Richard Quasarano  
SOCRE Environmental Project Manager  
San Diego Gas & Electric Company  
(T) 858-654-8211

**Re: Addendum No. 1 to the South Orange County Reliability Enhancement Project Notice to Proceed Request No. 6.**

**ATTACHMENT A**  
**NTP-6 Addendum Figure**

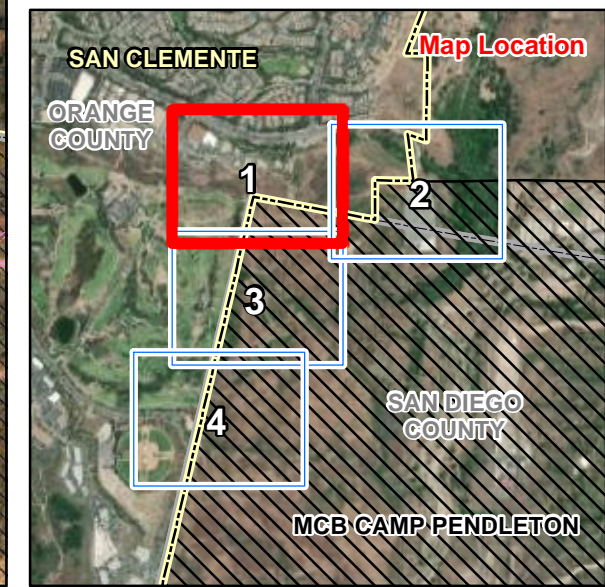
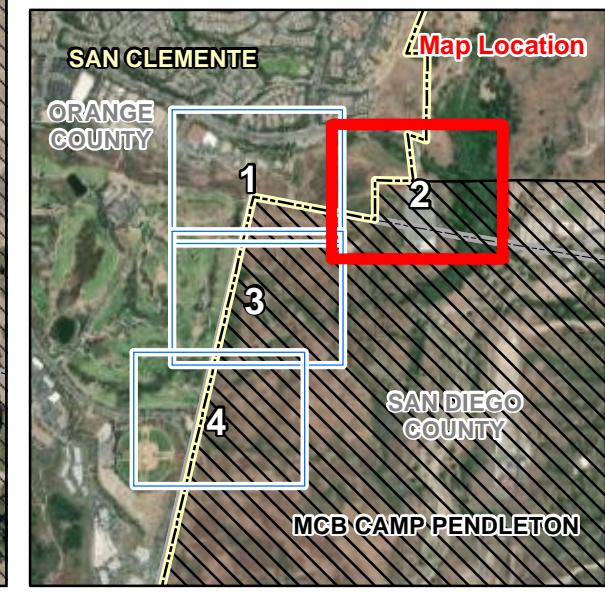
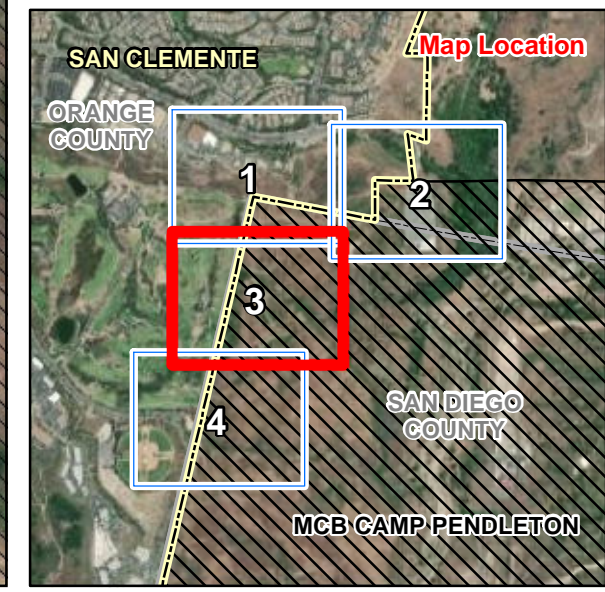
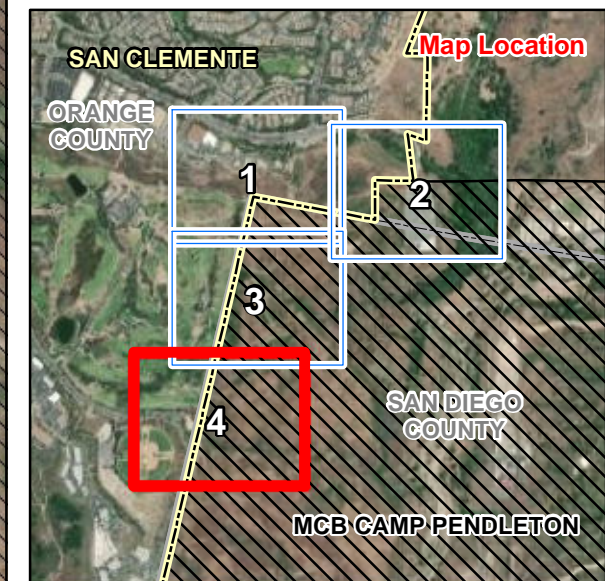
As mentioned above, NTP-6 authorizes construction activities between double-circuit standard steel pole #5 (approved in Notice to Proceed No. 5 [NTP-5]) and pole #41. This includes removal of the existing 138-kV transmission line and associated structures; construction of a new overhead double-circuit 230-kV transmission line; the installation of two 230-kV underground transmission lines along Stallion Ridge; and the installation of communications infrastructure. Pole #42 will be included in the overhead wire stringing section for poles #36-42. This work was originally anticipated to occur as part of the second phase of transmission line construction; however, it was determined that a schedule revision would allow for more operational flexibility and the Project is now rebuilding the transmission line through location 42 as part of the first phase of transmission line construction. Therefore, this amendment is being requested to remove existing 138-kV transmission pole Z221631 and stub pole Z226331 and install new 230-kV transmission pole #42 within the work area shown in **Attachment A, Addendum Figure**. In addition, stringing equipment may need to be set up within the Location 42 work area and/or nearby access roads in order to perform wire stringing from pole #36 to pole #42. Pole top work is anticipated at the existing structure Z247455 to the south of pole #42. Z247455 will be removed as part of the Project

however these activities will be included in the forthcoming Notice to Proceed No. 7 (NTP-7) Request. Access roads south of the Project alignment that may be utilized by the Project are also shown for reference in **Attachment A**.

SDG&E respectfully requests approval of Addendum No.1 to NTP-6 to perform the removal of existing poles Z226331 and Z221631, installation of pole #42, and pole-top work at location Z247455 by September 29, 2020. All activities will take place as conditioned in the CPUC's NTP-6 approval letter. Should you have any questions or need additional information, please do not hesitate to contact me at 858-654-8211 or by email at [RQuasarano@sdge.com](mailto:RQuasarano@sdge.com)
